**WEST GATE TUNNEL PROJECT ENVIRONMENT EFFECTS STATEMENT**  
**INQUIRY AND ADVISORY COMMITTEE**

**CITY OF MELBOURNE**

**TECHNICAL NOTE NUMBER:** #10

**SUBJECT:** **Further response to PN60**

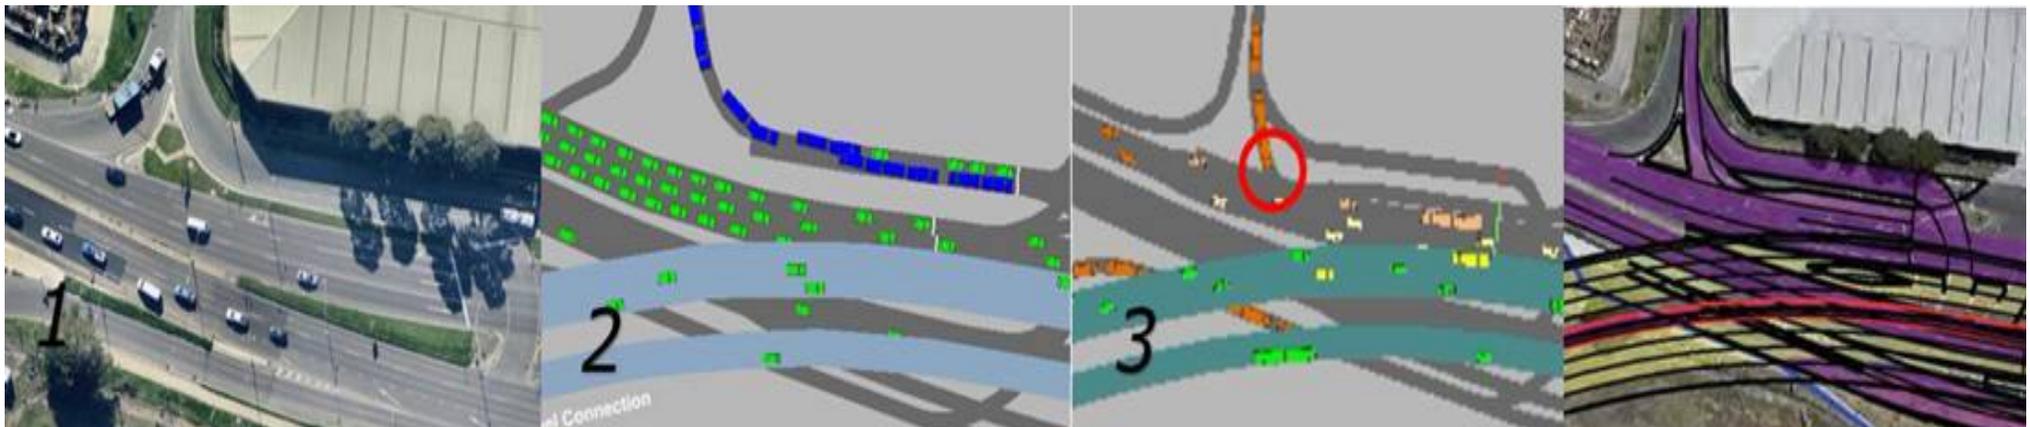
As shown in the images below, it has been observed that there is a material difference in the configuration of the Footscray Rd connection (Eastbound) in the Project Design and Option 5 microsimulation models that were provided as part of PN 40 (image 2) and PN 60 (image 3).

The difference makes a substantial difference to the operational performance of the connection (i.e. results in less capacity, longer delay and queues).

The Project Design as depicted in PN40 (Image 2) assumes this movement operates with a separate phase as part of the Linfox signalised intersection, offering superior capacity to that adopted under Option 5 for PN 60 (Image 3), where this movement does not benefit from traffic signals but is required to give way and pick gaps in traffic to enter Footscray Road (identified in the red circle in image 3 below).

There is no explanation for this difference given in PN60, and this difference would play a significant influence on the congestion that is depicted in Figure 1 of PN60.
